Access Compliance Report

Public Rights-of-Way

(Curb Ramps)

Intersection ID: 3874	Main Street: GARRISON_RD	Cross Street: MARBLE_HILL_DR	Location:	N
ADA ID: B296EA0C1B1B	Ramp Type: PerpDiag	Initial Pass/Fail: Fail	Overall Compliance: No	Severity Score: 30
Codes/Mitigation Info/Possible Solution		Field Measurements/Component Compliance

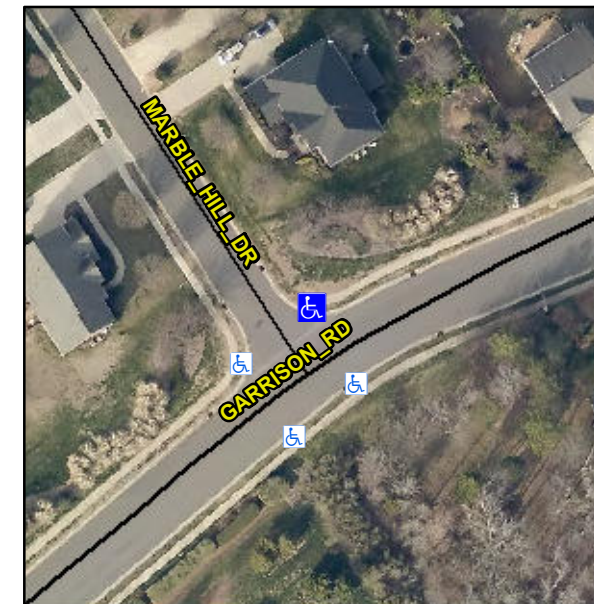
PROW/ADA:

Not Found, R304.5.1, R304.2.2

Compliance	Description	Data	Compliance	Description	Data
N/A	Ramp Length (in)	45.0	No	Ramp Slope (%)	9.4
No	Ramp Width (in)	35.5	Yes	Ramp XSlope (%)	0.9
N/A	Flare Type LT	N/A	N/A	Flare Type RT	N/A
N/A	Flare Slope LT (%)	N/A	N/A	Flare Slope RT (%)	N/A
N/A	Flare Traversable LT?	N/A	N/A	Flare Traversable RT?	N/A
N/A	Landing Length (in)	N/A	N/A	DWS Provided?	N/A
N/A	Landing Width (in)	N/A	N/A	DWS Contrast?	N/A
N/A	Landing Slope (%)	N/A	N/A	DWS Length (in)	N/A
N/A	Landing X Slope (%)	N/A	N/A	DWS Full Width?	N/A
N/A	Landing Curb? (Y/N)	N/A	N/A	DWS Offset (in)	N/A
N/A	Shared Landing?	N/A			
N/A	Gutter Ponding?	N/A	N/A	Gutter Slope (%)	N/A
N/A	Gutter Lip Ht (in)	N/A	N/A	Gutter X Slope (%)	N/A
N/A	Painted X Walk1?	No	N/A	Painted X Walk2?	No
	X Walk 1 Direction	To SE		X Walk 2 Direction	To SW
N/A	X Walk 1 Width (in)	N/A	N/A	X Walk 2 Width (in)	N/A
	X Walk 1 Slope (%)	2.8		X Walk 2 Slope (%)	1.1
	X Walk 1 X Slope (%)	0.3		X Walk 2 X Slope (%)	0.8

Possible Solutions:

Remove & Replace Curb Ramp With Two New Directional Ramps or Equivalent.
